PCN 22

Raspberry Pi 5 Revision 4 PCB

Change of Raspberry Pi 5 PCB to Revision 4.

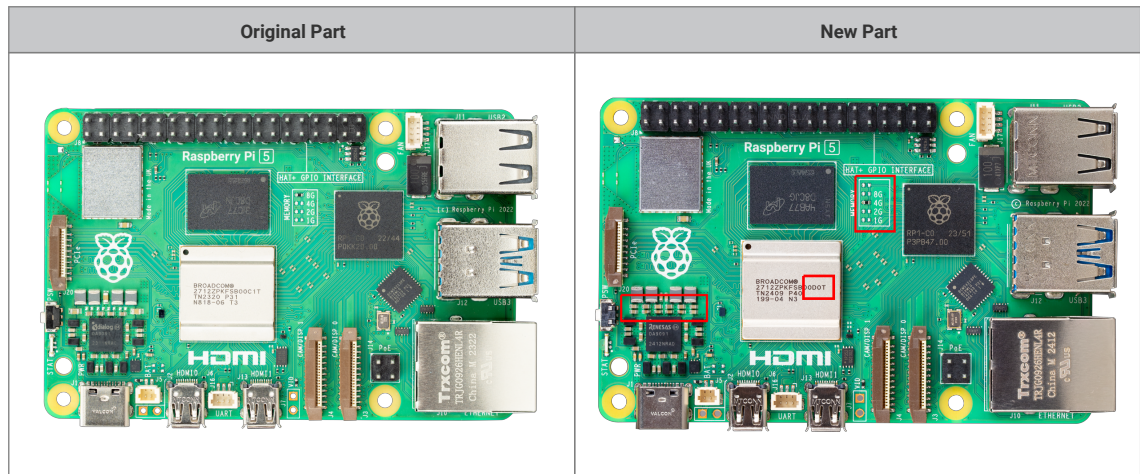
The new product can be distinguished by examination of the PCB. The revision 4 board has an extra link option in the memory box silkscreen on the top face of the PCB. There are now 6 similar components above the Dialog PMIC rather than 4. The final characters on the BRCM2812 device will contain **D0**.

See the red boxed areas on the images below for details.
